Title of Report:	Planning Committee Report – LA01/2024/0688/F
Committee Report Submitted To:	Planning Committee
Date of Meeting:	22nd October 2025
For Decision or For Information	For Decision – Referred item Referred by Alderman John McAuley
To be discussed In Committee YES/NO	NO

<u>No:</u> LA01/2024/0688/F	<u>Ward:</u> Ballycastle
<u>App Type:</u> Full	
<u>Address:</u> 8 Cedar Avenue, Ballycastle	
<u>Proposal:</u> Retrospective application for proposed replacement dwelling as built for residential purposes - (change of house type from LA01/2016/0956/F	
<u>Con Area:</u> n/a	<u>Valid Date:</u> 13.06.2024
<u>Listed Building Grade:</u> n/a	
Agent: MKA Planning Ltd, 32 Clooney Terrace, Waterside, Derry	
Objections: 27	Petitions of Objection: 0
Support: 0	Petitions of Support: 0

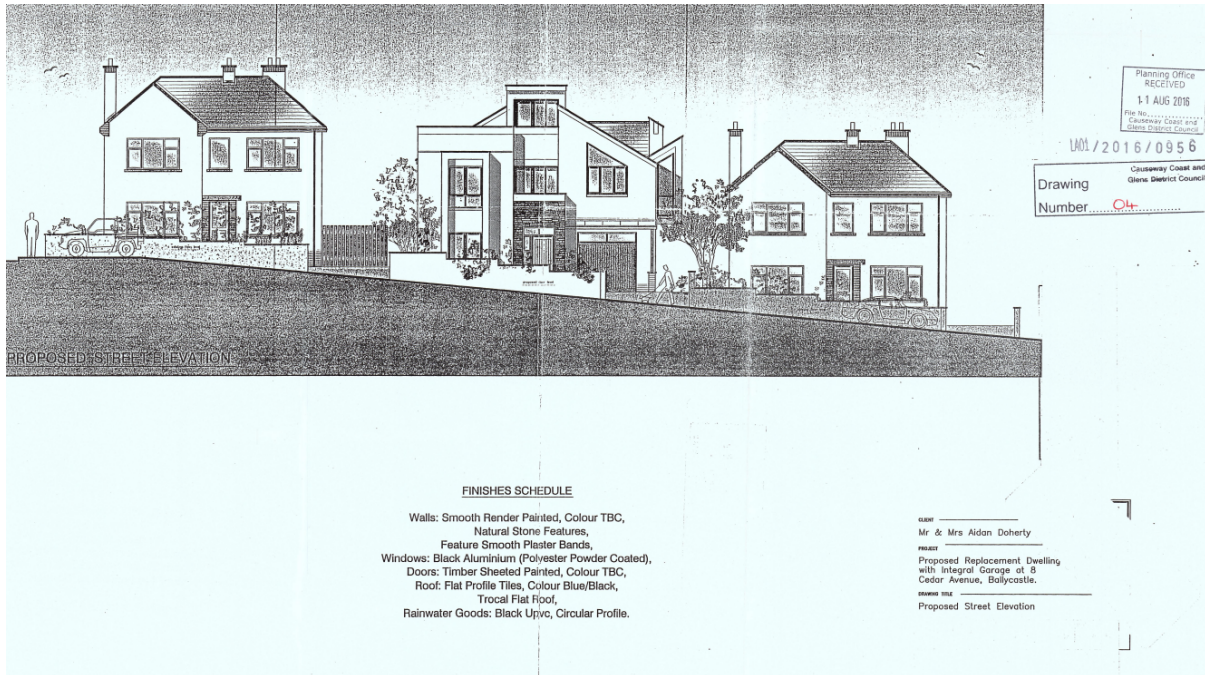
- 8.27 The site is within an established residential area within the development limit of Ballycastle. The use of the site for residential is considered an appropriate land use.
- 8.28 To the immediate south-east of the site is no. 6 Cedar Avenue. This is a 2-storey detached dwelling and sits at a lower level to the application site. The rear private amenity space of No 6 is directly overlooked by the 1st and 2nd floor rear balconies. Where balconies and roof terraces had previously been approved under the previous applications these are now surrounded by glazed balustrades. The agent was advised that the balconies are unacceptable due to overlooking and also the perception of overlooking. Amended plans now show a coloured panel to the balconies and obscure glazing to be provided to the 1st floor balcony. The coloured pvc panel is 1.1m high which will

not prevent overlooking into the neighbouring property. The 2nd floor rear external area was previously approved as a roof-terrace. However, this has now been opened up on 2 sides with glazing which results in unacceptable overlooking and impact on private amenity on the adjacent properties, in particular No 6 Cedar Avenue and No 8 Cedar Drive (north-east). Amended plans were received replacing the glazed elements with a wall. The agent has clarified that the height of the wall is to be 1.2m as previously approved. Given the location of the balconies and roof terrace when using these the private rear amenity of the neighbouring properties including No 10 Cedar Ave, No. 6 Cedar Avenue and No 8 Cedar Drive will be directly overlooked from the 2nd floor roof terrace. The 2nd floor roof terrace is located less than 1 metre from the shared boundary with no. 10 Cedar Ave. Concern has also been raised regarding the potential noise generated from the roof terrace which lies in close proximity to 2nd floor bedroom windows on this property. Both the front and rear 2nd floor balconies measure approximately 18 square metres which could accommodate several people and result in an impact on private amenity.

- 8.29 Due to the orientation of the 1st floor balcony and the limited depth of the rear garden at No 6 Cedar Ave, the rear amenity of this property is entirely overlooked.
- 8.30 The existing vegetation to the north-eastern boundary provides partial screening to No 8 Cedar Drive when viewed from the 1st floor.
- 8.31 The north-eastern facing window on the overhang section currently overlooks the rear amenity space of No 6 Cedar Avenue. Amended plans have been submitted to show this window to be provided with obscure glazing to be permanently retained. This would limit the overlooking of the private amenity space of the adjacent dwelling.
- 8.32 The 1st floor window of on the south-eastern side elevation (northern end) also overlooks the amenity space immediately to the rear of No 6 Cedar Avenue. This window serves an open plan kitchen and living area and there are other windows which

- 8.34 The 1st floor overhang on the side elevation is larger than previously approved, it has now been squared off, it runs level with the site boundary and a new window has been created on the north-western rear elevation, this window looks out towards the rear amenity space at No 6 Cedar Ave. Concern has also been raised that the overhang section has blocked light into the bathroom of the adjacent dwelling. The Addendum to PPS 7, while referring to residential extension and alterations provided guidance regarding level of loss of light and -states that 'In terms of daylighting, the effect on all rooms, apart from halls, landings, bathrooms and utility rooms will be considered. As such, the level of loss of light as a result of the overhang is not considered so significant to merit refusal for this reason.

- On the first-floor rear balcony the balustrade is to be amended at the southern end. It is to be increased in height from 1.2m to 1.8m and this section will have an opaque film applied to the face of glass, this will extend for 1m along the rear elevation.

- The southern facing (side elevation) corner window on the 1st floor will have an opaque film applied to the inside of the existing glass.
- The north-eastern facing (rear elevation) 1st floor window of the overhang section will have an opaque film applied to complete inside face of existing glass.

- The existing glazed balustrade on the 2nd floor rear roof terrace will have opaque film applied to the face of the glass to both rear and side elevations.

- The north-western facing side elevation of the second-floor rear roof terrace will be increased in height from 1.2m to 1.5m with a solid timber panel constructed on top of the existing wall.
